Service Bulletin S/B 1013

Mini Deck Front Support Product Enhancement Kit

Date: 12/10/15

Photo # 3:

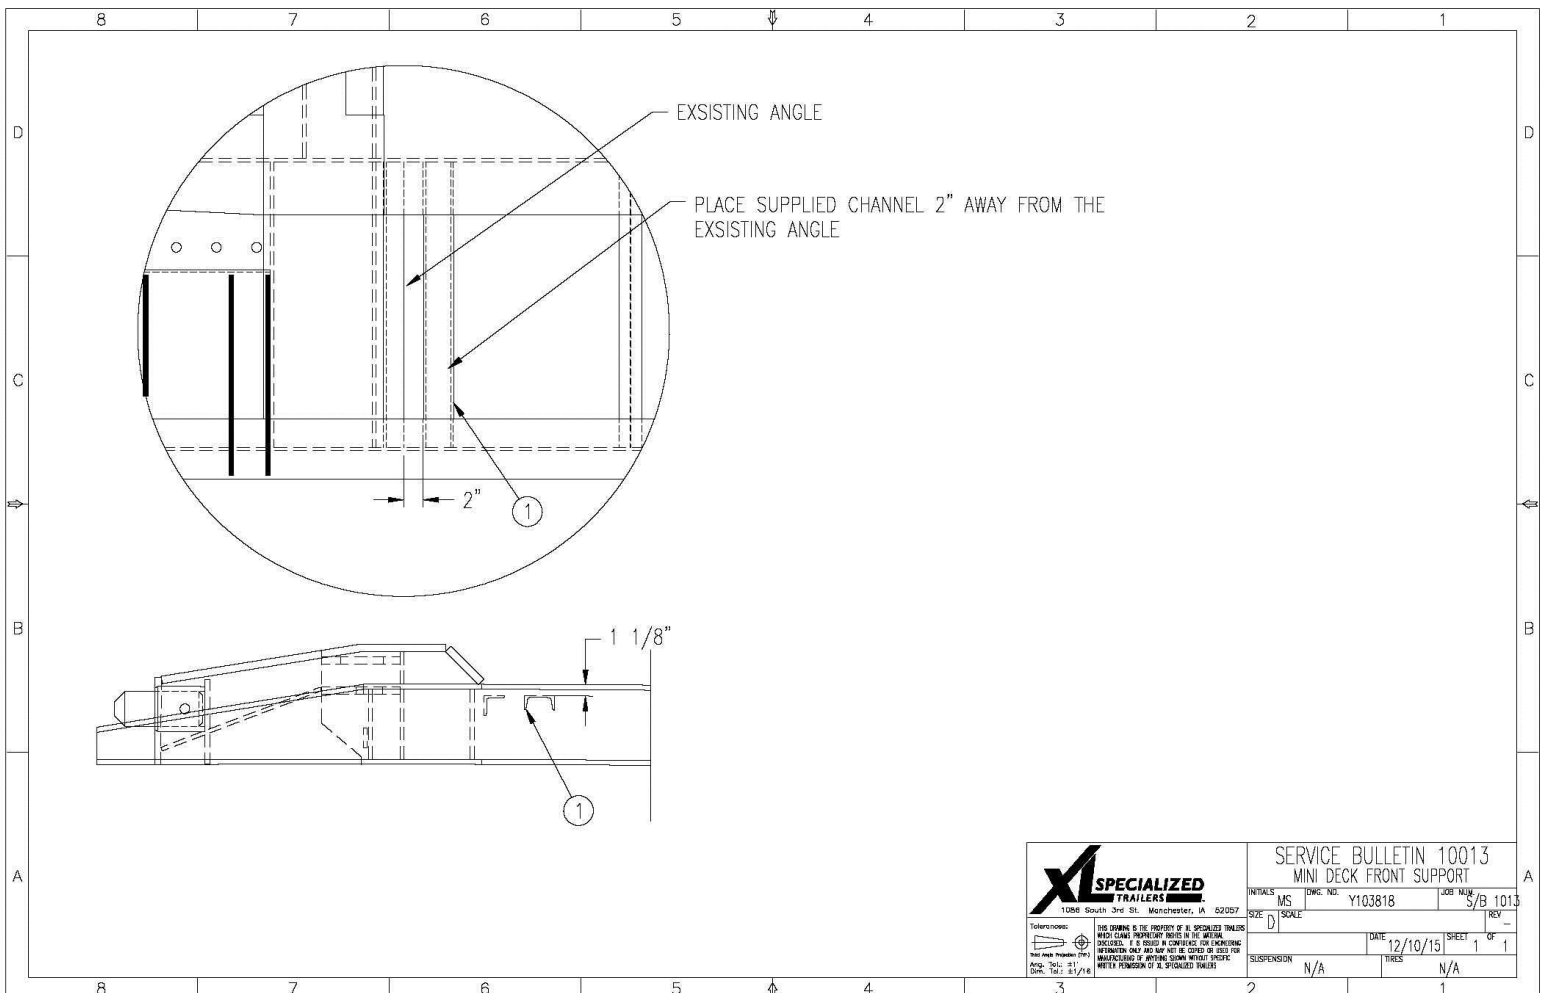
Schematic showing installation of 3" channel. Please remember to paint top side of channel before installing.

1. Place front end of trailer on sawhorse for access to underside of trailer
2. Primer/paint top of 3" channel before installation
3. Unhook and pull back air/electrical hoses
4. Install 3" channel per Photo # 3
5. Weld around 3" channel, excluding top portion of channel (minimum of 5/16" fillet weld)
6. Primer & paint new 3" channel and affected areas
7. Re-attach air/electrical hose & test function
